**Carlyle/Eisenhower East Design Review Board (DRB)
Application**

PROJECT NAME: Blocks 4+5 Hoffman Town Center BLOCK: 4+5

Carlyle Design Review Board
Submission-July 18, 2019 Hearing
2410 & 2460 Mill Road
HTC Block 4 & 5
19-0007

RE: Hoffman Town Center, Blocks 4 & 5
DSUP #2019-0018
Comment Response Letter
Cooper Carry project# : 20160037

1 EAST ELEVATION
4-A4.02 SCALE: 1/16" = 1'-0"

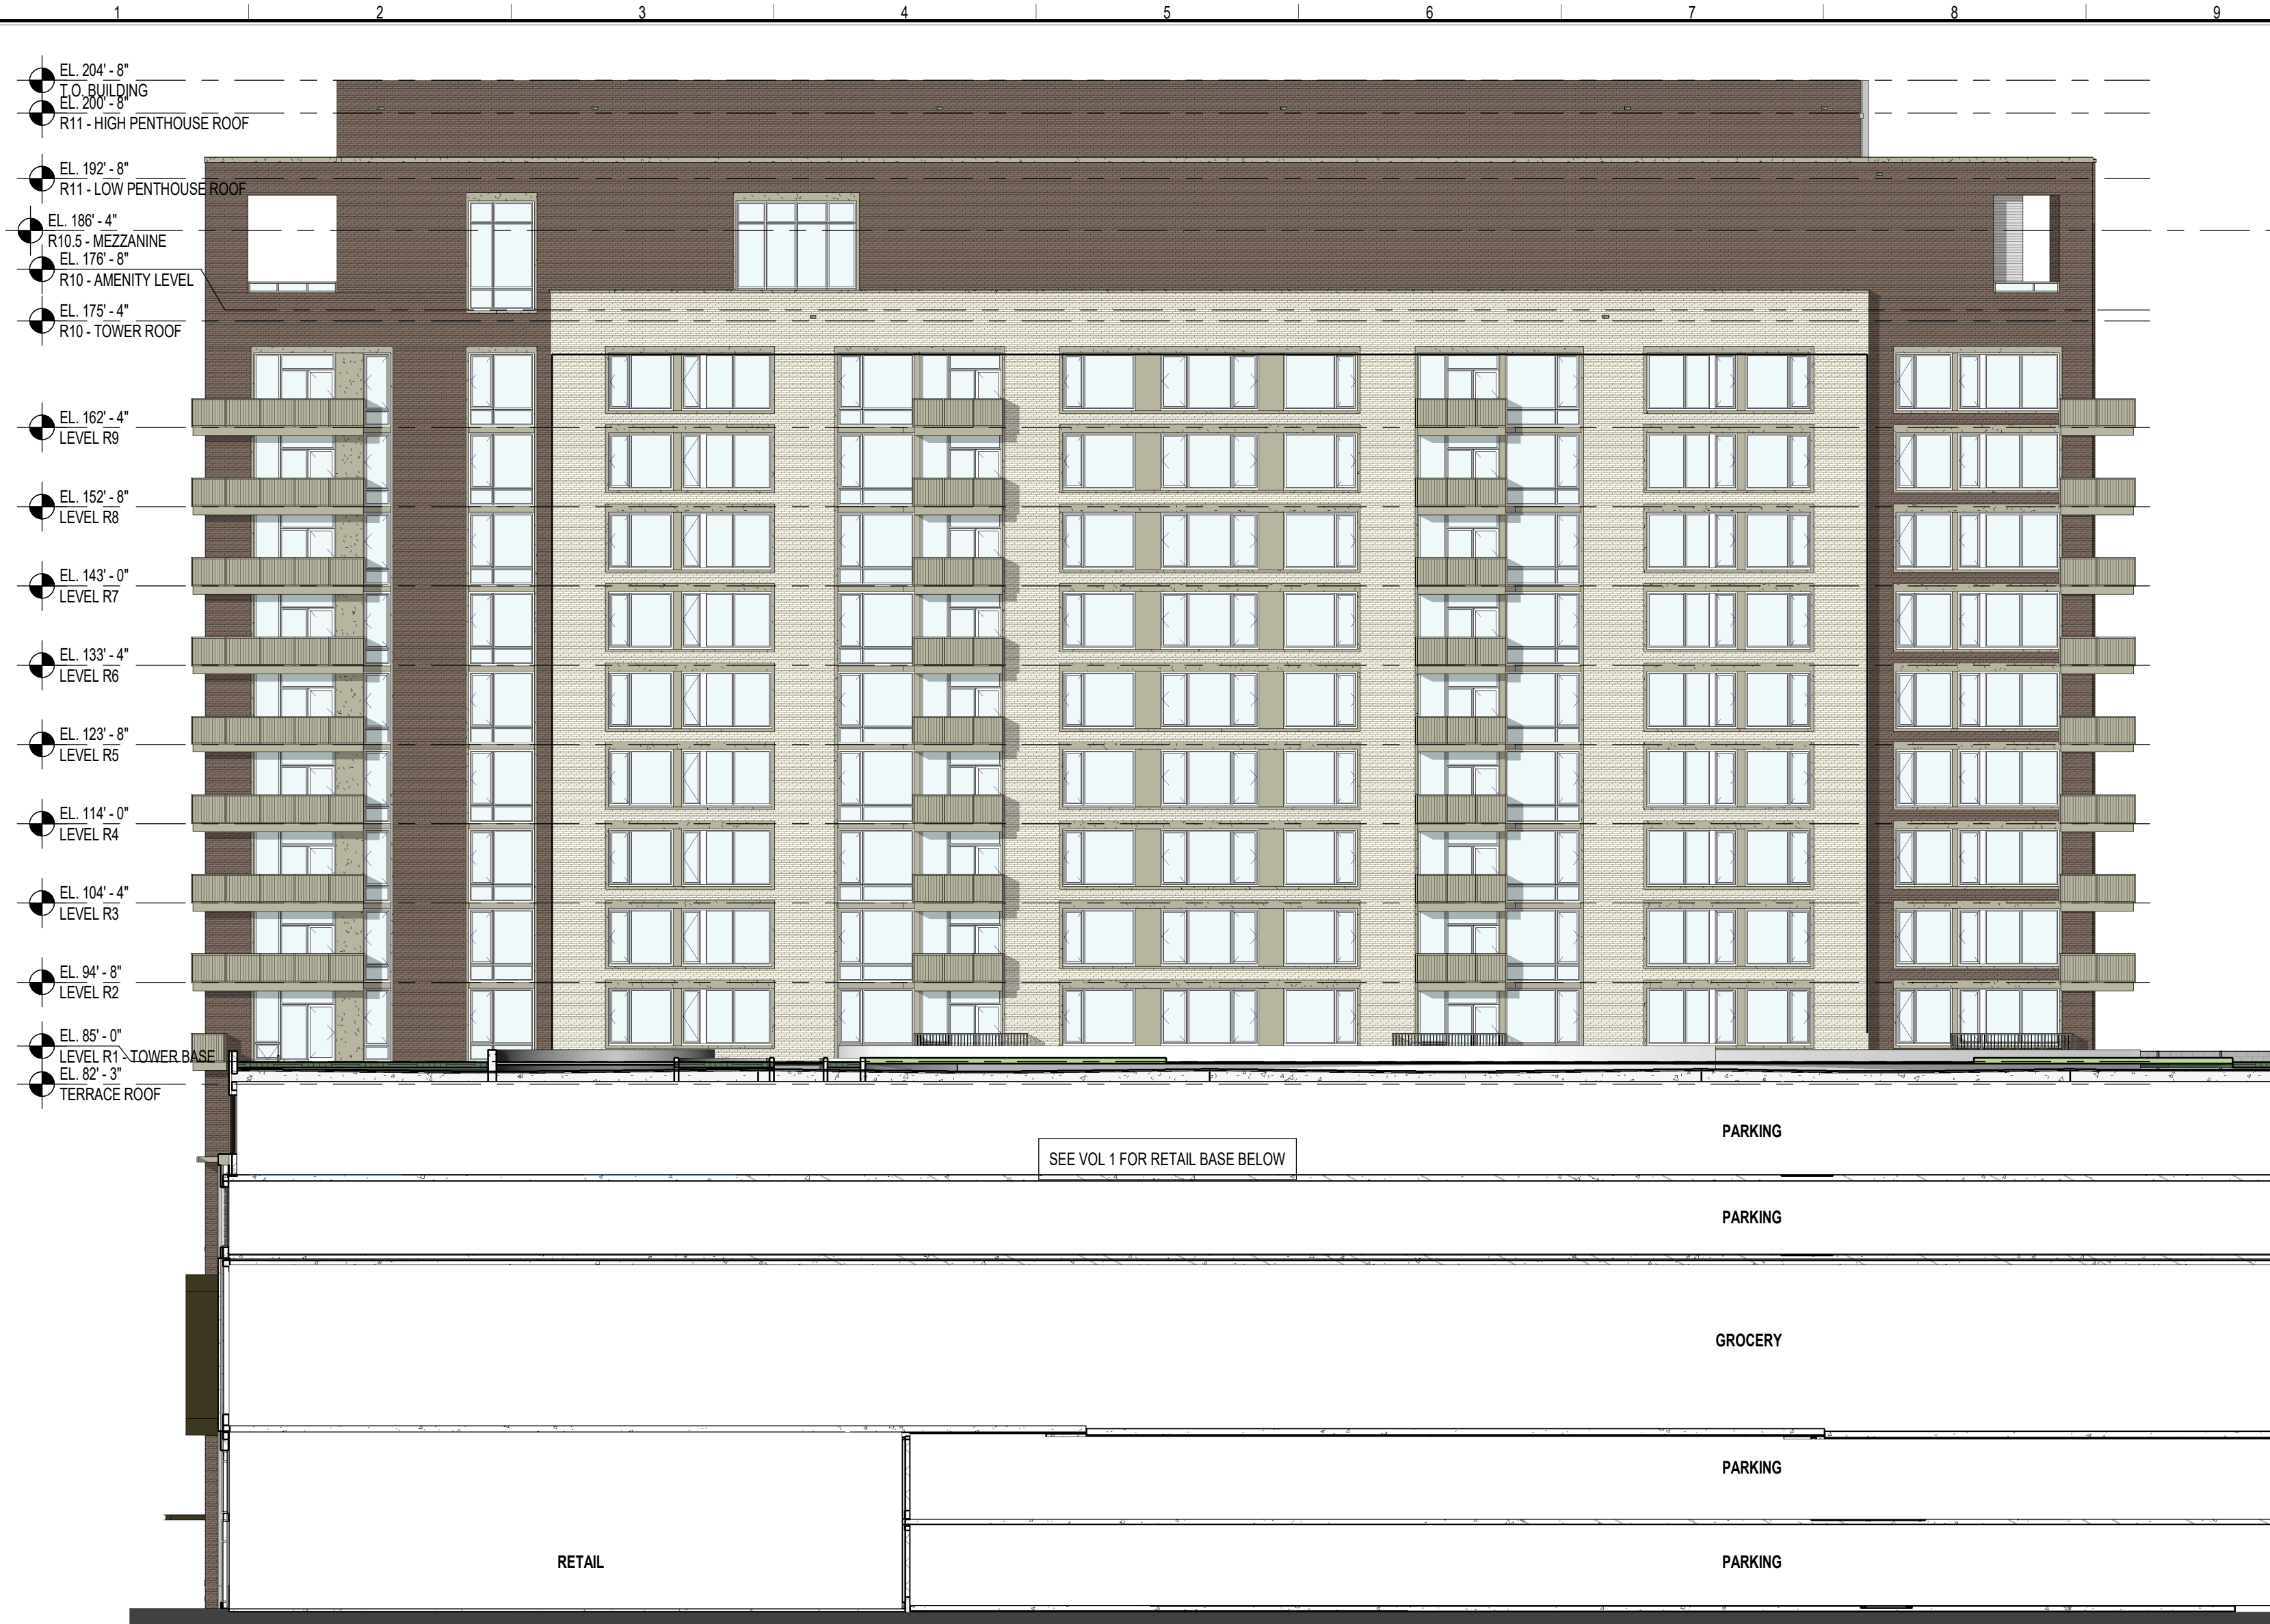
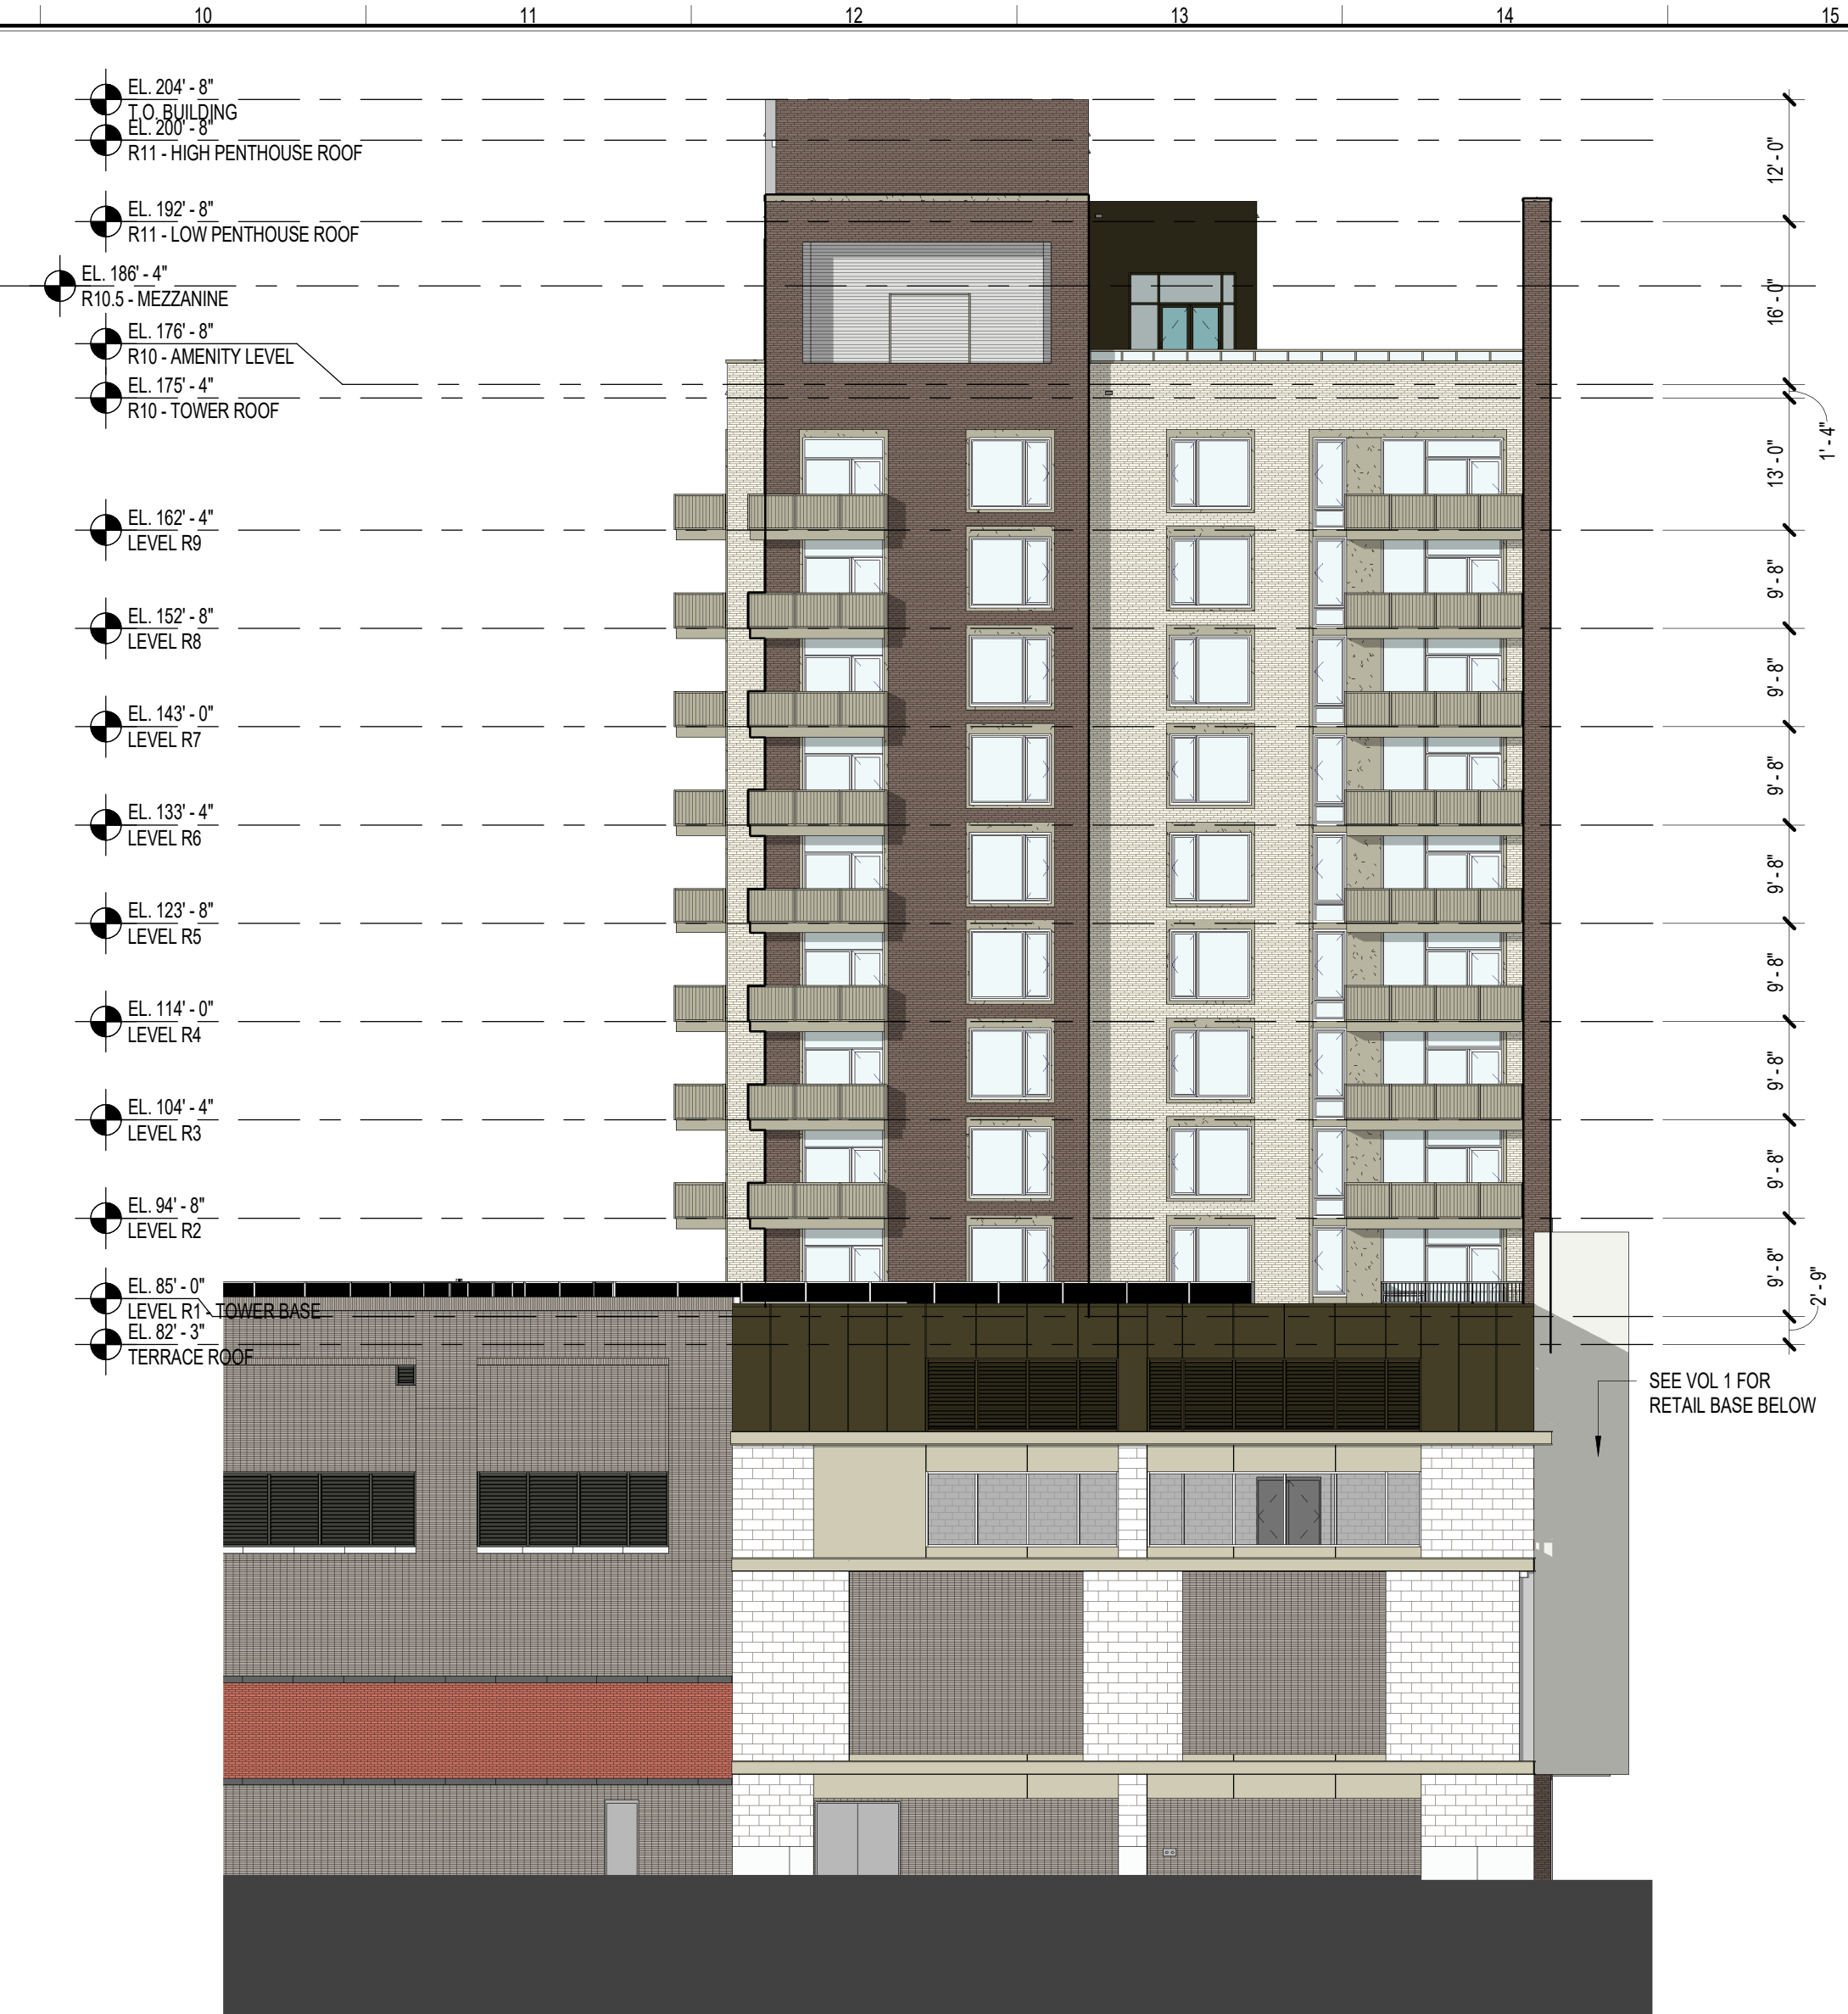
- h. The bays spacing on the approved east elevation reflected the west elevation, now incorporates varied bay and pier widths, creating a symmetrical pattern that diminishes the strongly asymmetric cues of the approved design.

- g. The west half of the north elevation has been completely changed from primarily glass to primarily solid, again with a change from large to small windows, a complete change in wall and opening proportions, and the relocation of many balconies.

Response: Glazing has been restored with the exception of one window on the east elevation which was removed due to a change in the program of the space now reserved for mechanical equipment.

Response: The difference in bay spacing has been driven by the change in program from a condominium to an apartment building. Although the number of units has increased, the five-bay rhythm has remained on each elevation and has been revised to match the approved DSUP as much as possible. Due to constraints regarding the building’s structure, as well as unit configuration, the glazing on the east elevation resulted in a symmetrical pattern.

Response: The north elevation's modification is reflected in the change in footprint in the DSUP Amendment. With this footprint change, the interior units have been changed as well. The glazing has been maximized as much as allowed by the interior unit layout with floor-to-ceiling glass where appropriate. The balcony on the west half continues to wrap the corner and the elevation is further enhanced with the addition of a larger balcony to the adjacent cream-color portion.
